# Start-up Training Sequence Proposal

May 9, 2006 T10/05-397r3

# New table for Speed Negotiation Window Rate G3

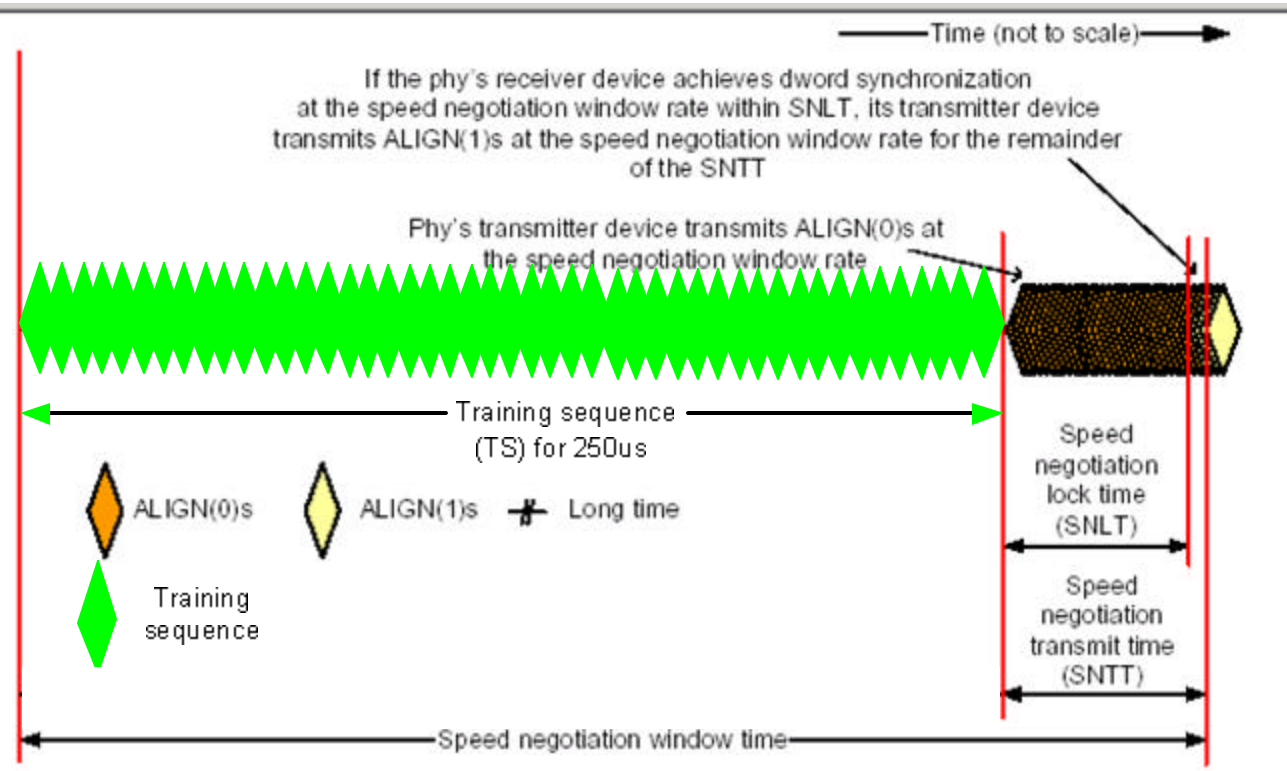
Parameter	Time	Comments
		The time the transmitter device shall transmit D.C. idle between rates during speed negotiation.
Speed negotiation transmit time (SNTT)	163 840 OOB1	The time during which ALIGN (0) or ALIGN (1) is transmitted at each physical link rate during the speed negotiation sequence. Derived from: $OOB1 \times 4\ 096 \times 40$ .
Speed negotiation lock time (SNLT)	153 600 OOB1	The maximum time during the speed negotiation window for a transmitter device to reply with ALIGN (1). Derived from: $OOB1 \times 3\ 840 \times 40$
Speed negotiation window time	913 840 OOB1	The duration of a speed negotiation window. Derived from: $RCDT + SNTT$ .
Training sequence (TS)	750 000 OOB1	Training sequence.

# Training Sequence Only Used for G3 Speed Negotiation

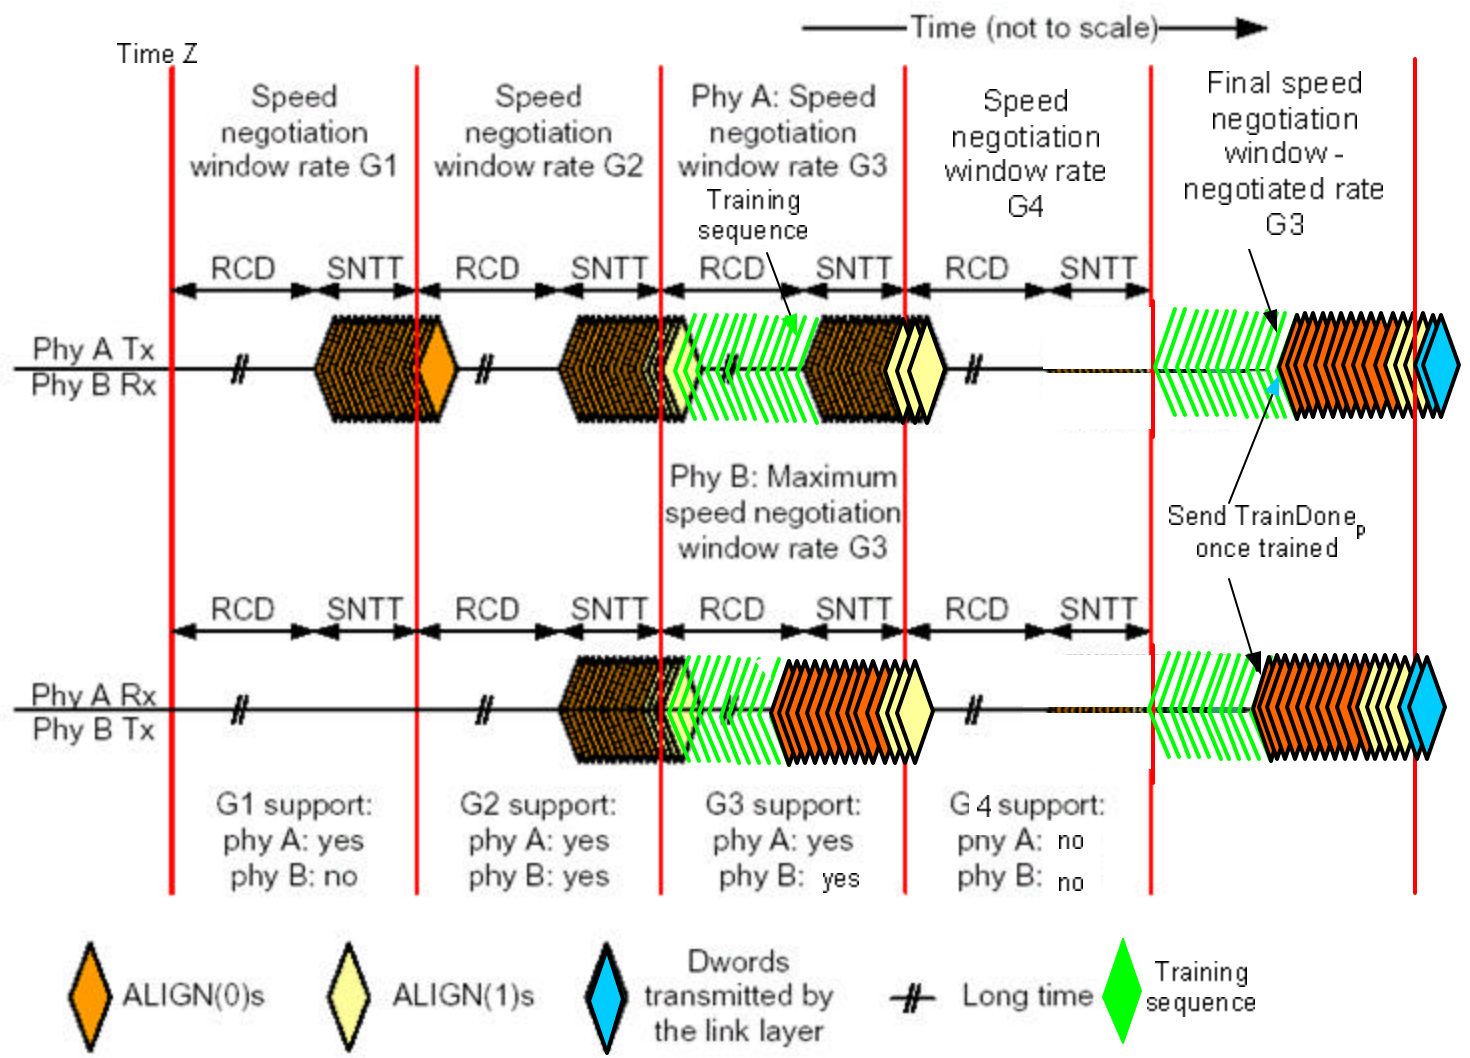
Pattern	Purpose	Time
Primitive sent twice	80 bits - Status or request	13.3ns
Scrambled data starting with seed 0h	800 bits - pseudo-random	133.3ns

D30.3 = 0111100011 1000011100b low frequency to provide an open eye.

Train<sub>p</sub>: training receiver K28.5 D30.3 D30.3 D30.3

~~IncEmp<sub>p</sub>: increase transmitter emphasis K28.5 D10.2 D30.3 D30.3~~

~~DecEmp<sub>p</sub>: decrease transmitter emphasis K28.5 D30.3 D10.2 D30.3~~

TrainDone<sub>p</sub>: training complete K28.5 D30.3 D30.3 D10.2

~~Done (Phy Adjust)<sub>p</sub>: adjustment acknowledged K28.5 D30.0 D16.7 D01.4~~

~~NAK (Phy Adjust)<sub>p</sub>: adjustment not acknowledged K28.5 D01.4 D31.4 D29.7~~

~~Amplitude adjustment?~~

# Final G3 Speed Negotiation Window Expanded

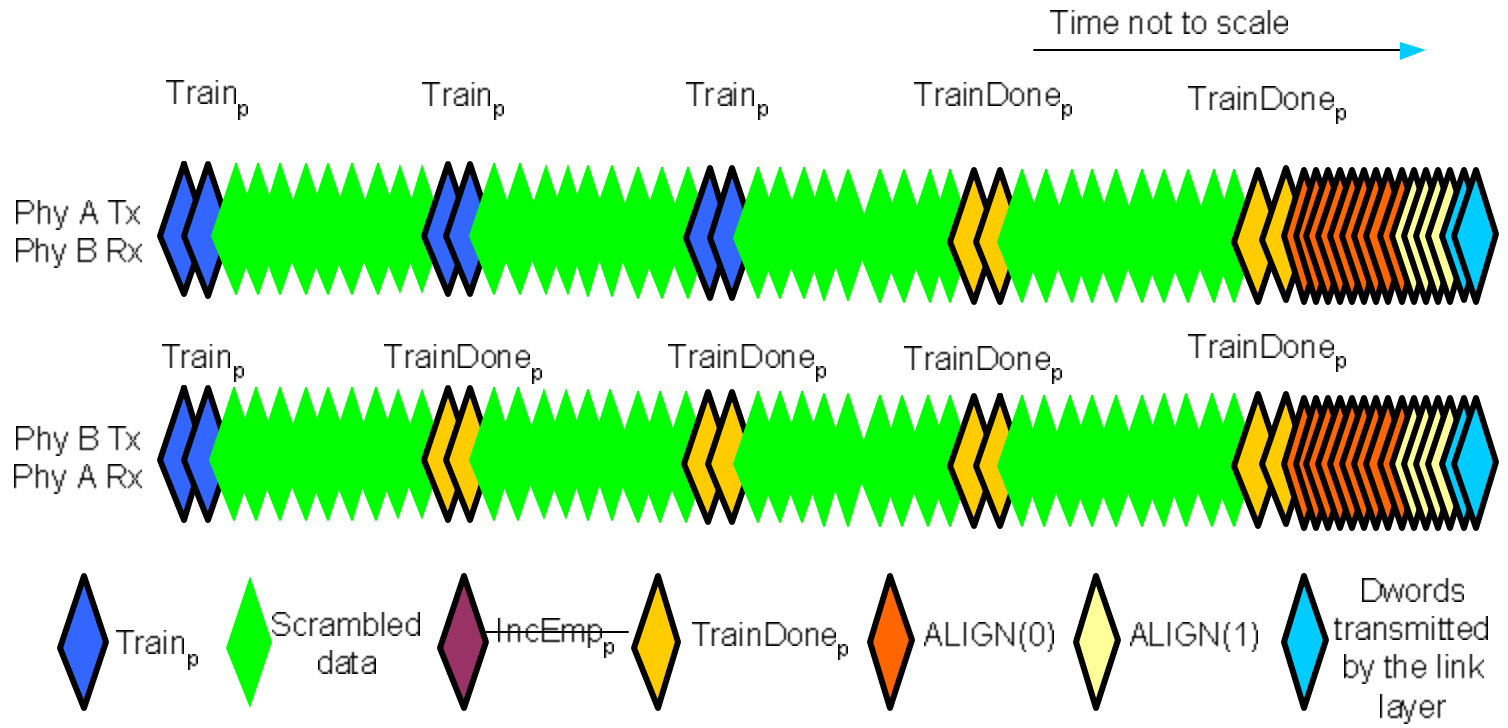
If  $TrainDone_p$  not received from both phys within 20ms then restart OOB.
